CITY OF PORTLAND, MAINE
HISTORIC PRESERVATION BOARD

**WORKSHOP – ADVISORY REVIEW and COMMENT
425 FORE STREET PARKING GARAGE**

**WORKSHOP
121 CENTER STREET**

Image-06

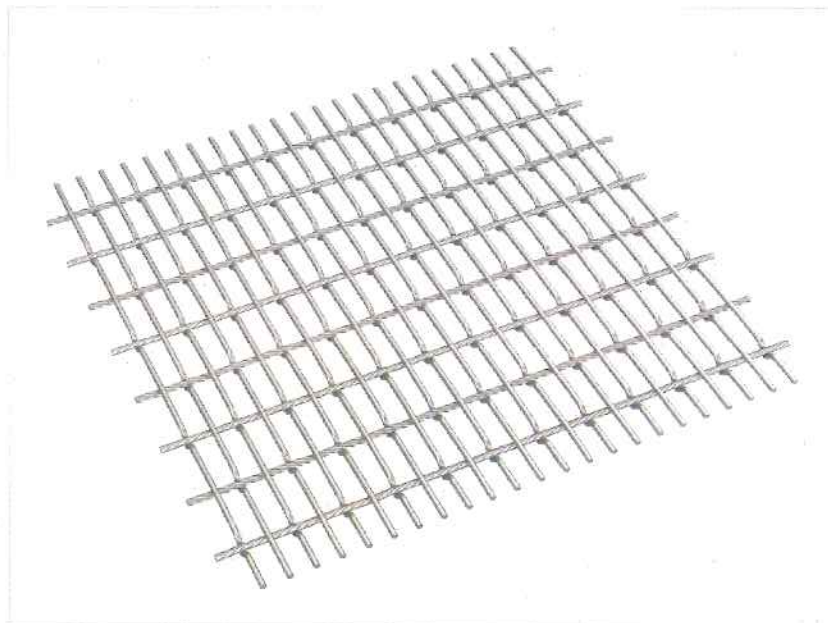
- Staff is unclear as to the transparency of the mesh. How large are the openings in the mesh?
- Will the mesh be reflective or dull? The south-facing exposure and use of stainless steel raises the question of the shininess of the material. Are other finish options available?

FORE STREET GARGE PROPOSED RENOVATIONS

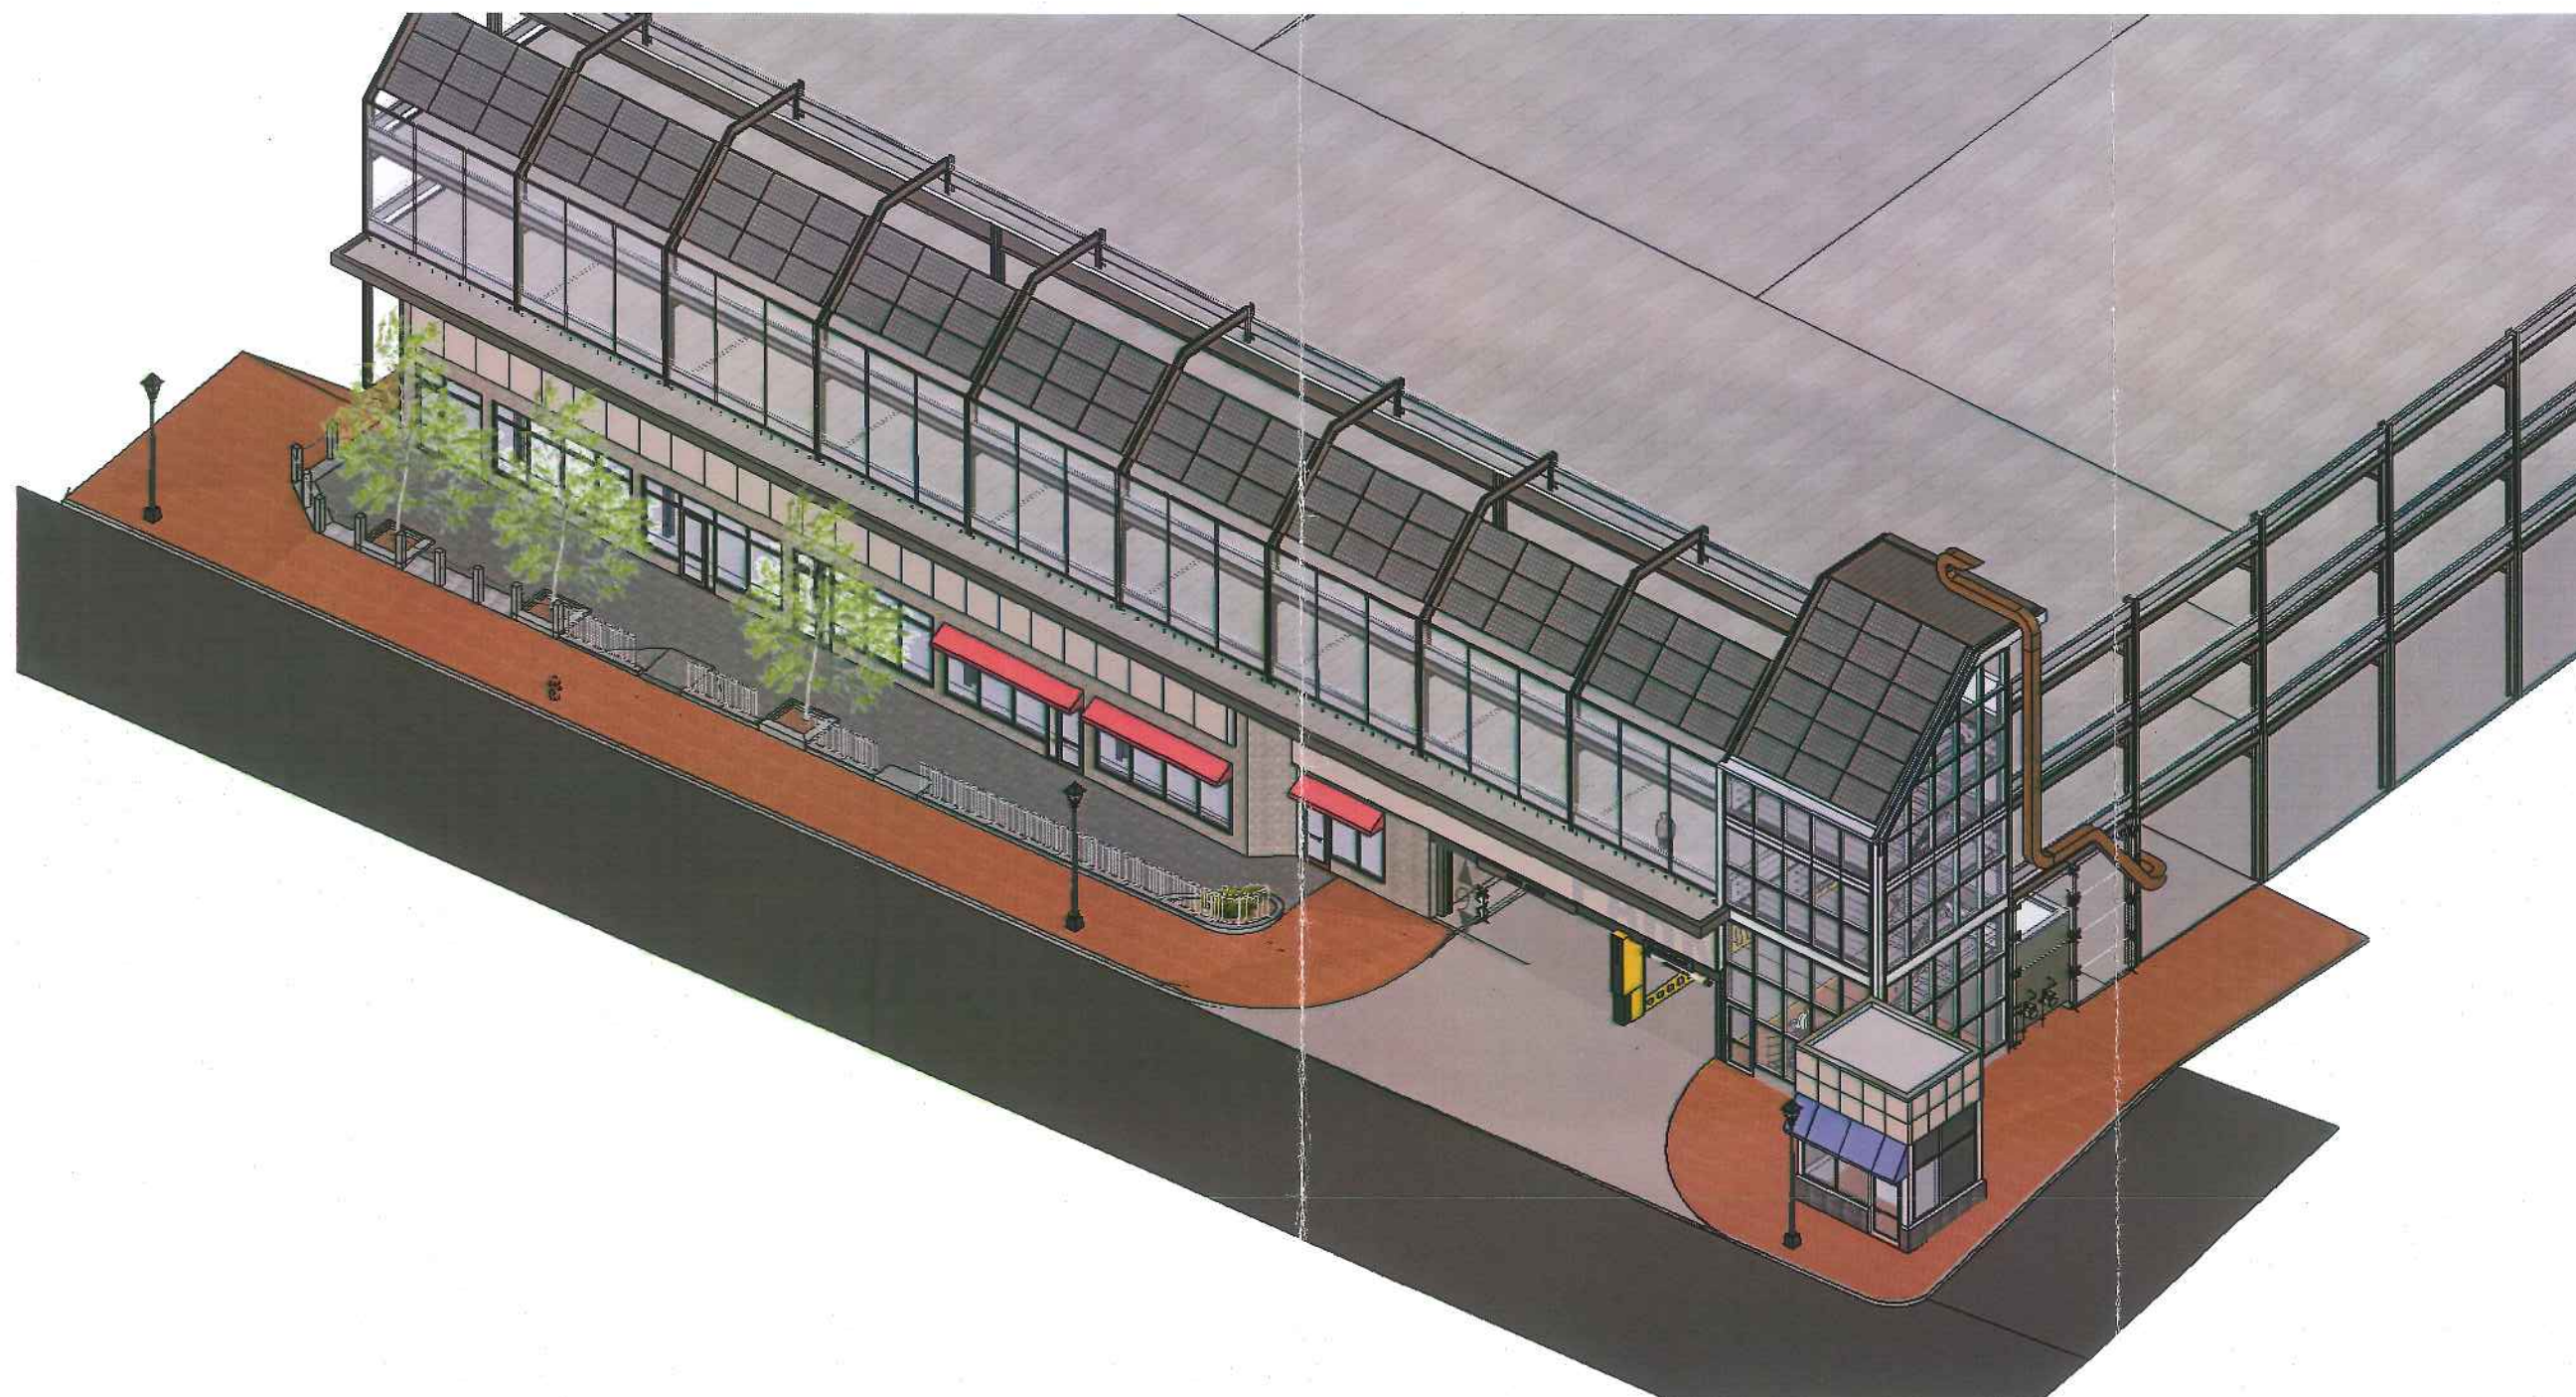
- What is the “architectural edge” listed in part 2) of the Summary? It appears to include a shallow projecting canopy over the vehicular entrance, and perhaps a slight overhanging band over the storefronts as well.

- Will the edge of the second-level parking include a vehicle guard that is high enough to block the headlights of cars parked facing Fore Street?
- Currently the lower of the two brick bands is in a plane closer to the street than the upper band. Staff is unclear how the two levels will be aligned to be spanned by the new screen.

- How rigid is the proposed screening? The rendering states the mesh panels are stretched, using “tension mounting springs.” Will panels move at all in high winds?

- What are the anticipated maintenance needs? Will mesh accumulate trash and leaves or dust that might be hard to clean?

PROJECT UPDATE

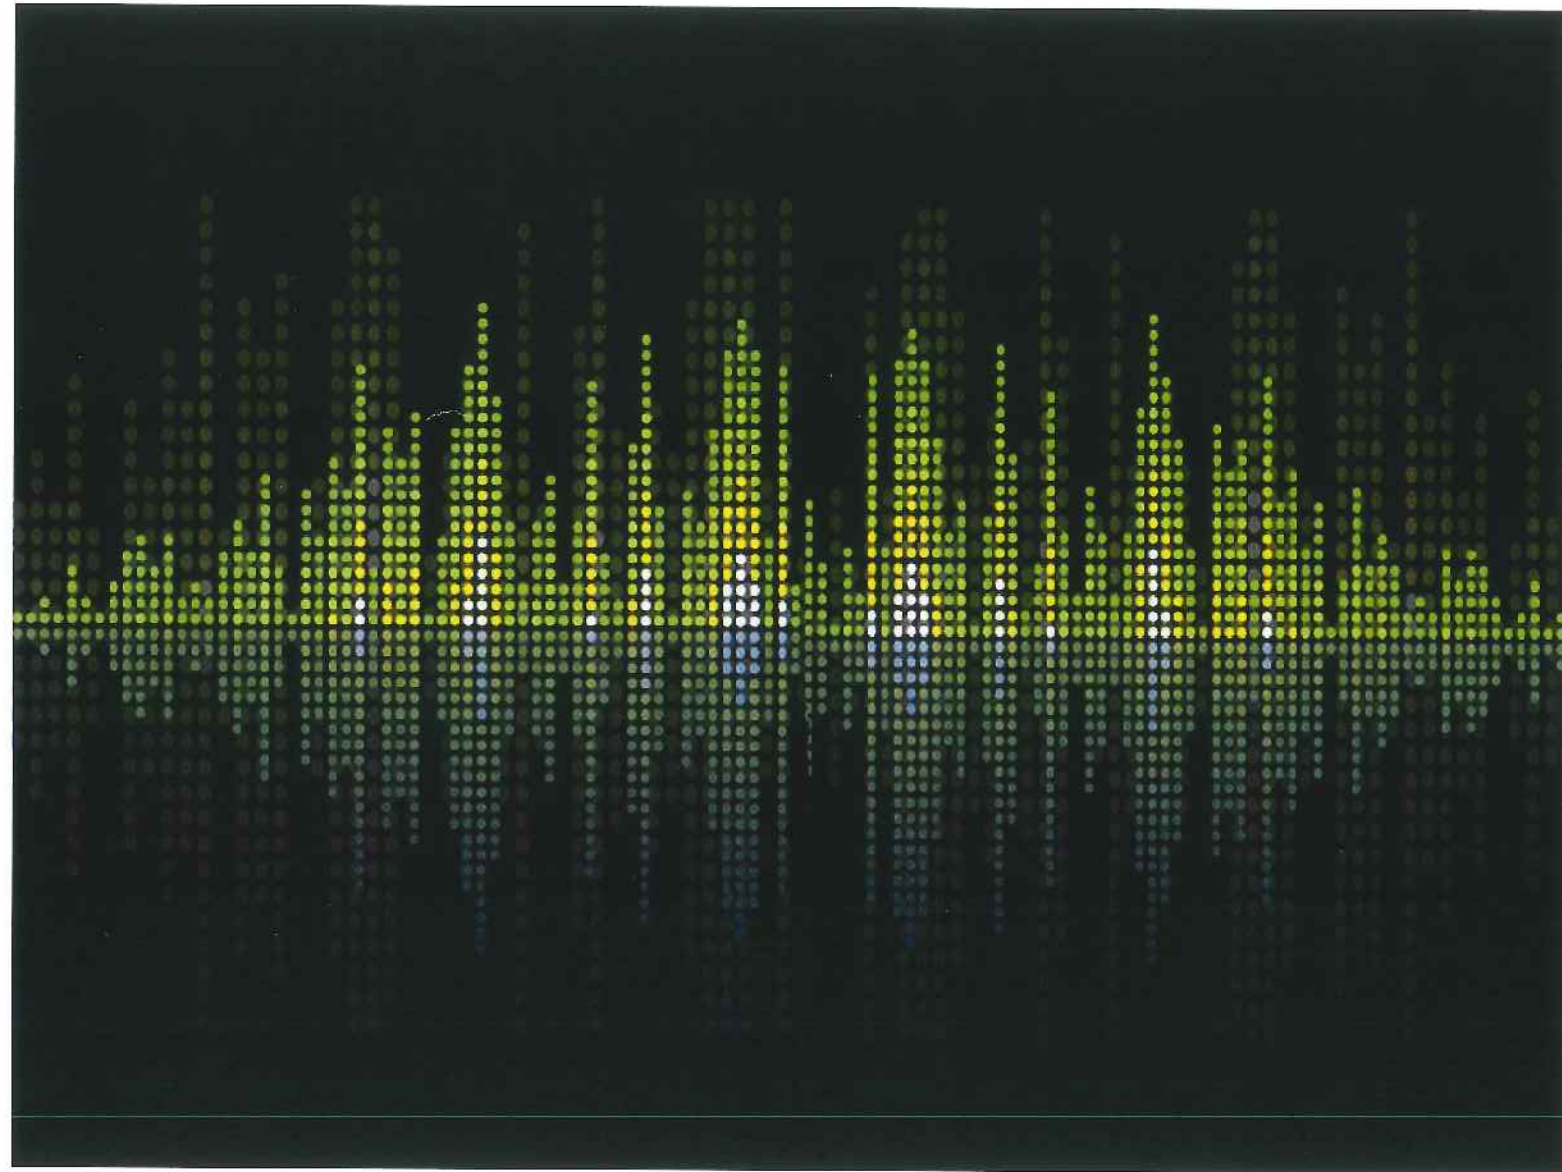
Please see Ms. Boothe's description of the new design included with this submission. On page 3, the new design is also shown compared to the design reviewed in January. Note that the new proposal shows the massing of the building shifted; the 3-story addition shifted away from the garage and toward the Center/Free Street corner of the building. The addition, which now reads as a distinct, monolithic volume or box, is also considerably larger—wider, taller and deeper--than previous iterations. On Center Street, the ground floor brick wall continues to the corner, with the facade of the addition, clad in metal panels, set back behind this wall plane. The brick is continued on the Free Street façade, along a portion of the base and extending to the roof at the eastern edge of the building. This "wrapping" effect of the brick further accentuates and sets off the single box-like massing of the theatre addition.

Just as the massing of the upper-story volume is undifferentiated, so too is the fenestration. The new design features a 2+ story single wall of glass subdivided by mullions. In some of the illustrations, a perforated metal screen with a large graphic covers this glass wall. Given the fact that the building is shown with and without this screen, it appears that this feature is still under discussion.
